Request for more Geotechnical information – Eastern Hills Reservoir Notice of Requirement

Please find below our response to your letter dated 3 July 2024 asking us to respond to comments in the geotechnical peer review carried out by ENGEO on behalf of Hutt City Council.

2.1.1.1.1 Calculation results, RSN1633_T_1_9211 [Phase_4] (4/11030), Total displacements $|u|$

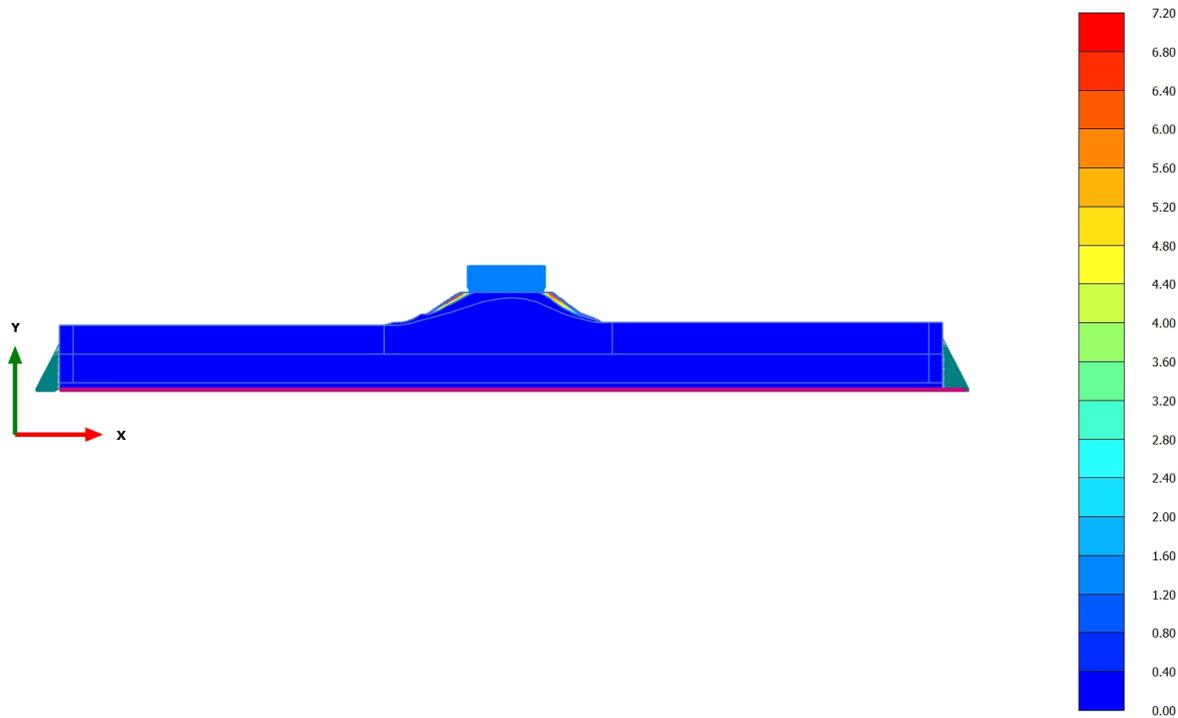
3. 8.2.2 – Dynamic Finite Element Analysis: Please provide all material properties for review.

4. 8.2.2 – Dynamic Finite Element Analysis: The report states that the Mohr-Coulomb model was used in the analysis. Low strain shear stiffness and damping has been determined iteratively.

Please provide additional details of how appropriate shear stiffness and damping were selected for each material. We also note that compared to the Mohr-Coulomb model, the Hardening Soil model with small-strain stiffness (HSsmall) is generally more appropriate for dynamic calculations as it includes strain-dependent shear stiffness and damping.

We have provided further details of the material properties and the dynamic model described in section 8.2.2 of the geotechnical interpretive report as Attachment 1

4.1.1 Calculation results, RSN1633_T_1_9211 [Phase_4] (4/11030), Total displacements $|u|$

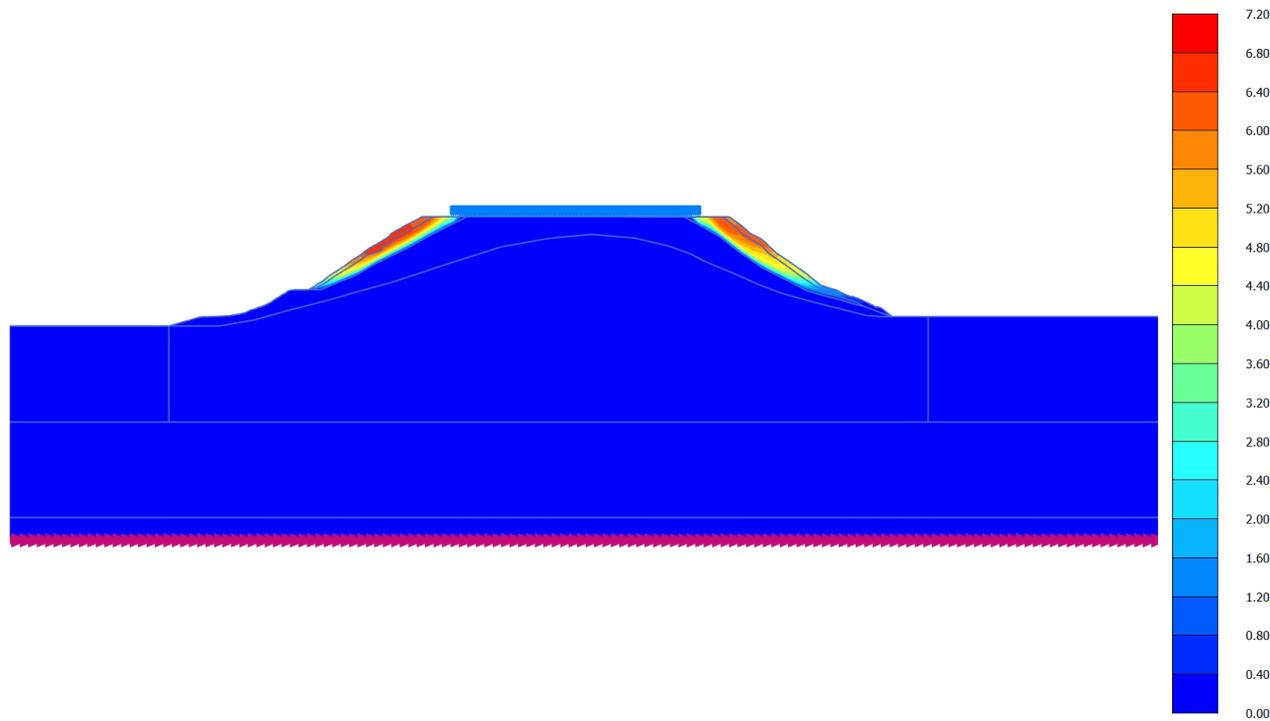
6. 8.2.4 – Results: Figure 8 shows typical displacement contours from the dynamic analysis and the report notes that the magnitude of the calculated displacements vary depending on the specific characteristics of the ground motions but area typically more than 1m and could easily be greater in reality considering the brittle nature of the rock.

Please provide a displacement contour scale for interpretation of Figure 8.

- 7. 8.2.4 – Results: The single output of results shown for the dynamic analyses (Figure 8) appear to be inconsistent with the pseudo-static analyses, which indicate that failure (or significant displacement) extending at least 30m under the tank foundations could be expected. While we appreciate the inherent differences in how these two types of analyses are performed, the estimate displacements from dynamic analyses appear low and localised in contrast to the pseudo-static results.**

We have provided a displacement contour scale as Attachment 1, but do not consider it particularly relevant to the site due to the brittle nature of the materials identified through previous ground investigations and the accuracy of these estimates at large strain. The structure is sensitive to ground displacements and displacement over 1 m is not likely to be tolerable by the structure.
